TAITO AMERICA CORPORATION

Subject: Moon Shuttle

81-7

GAME: MOON SHUTTLE

FIGURE 1

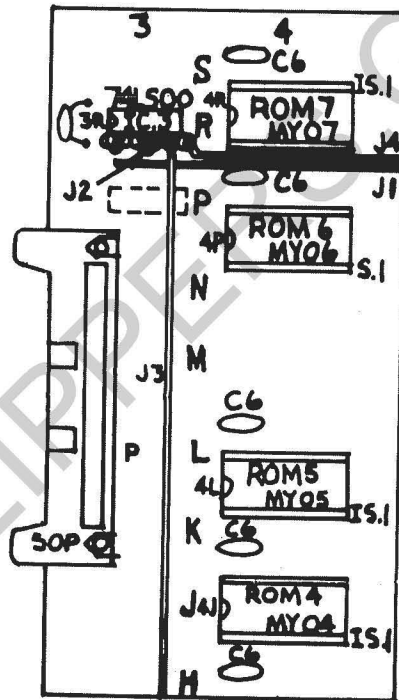
SUBJECT: MISSING SOUND, CONSTANT TONE OR SOUND DISTORTED.

MOSTLY A HEAT PROBLEM.

SOLUTION: ADD A CAPACITOR TO FILTER OUT NOISE ON +5V ETCH

PARTS NEEDED: ONE 0.1uf CAPACITOR

PROCEDURE: ADD 0.1uf FILTER CAPACITOR AT LOCATION 3R AS SHOWN IN
FIGURE 1. MAKE SURE YOUR HAVE AT LEAST 4.9V ON THE 5V
BUS LINE ON TOP BOARD.
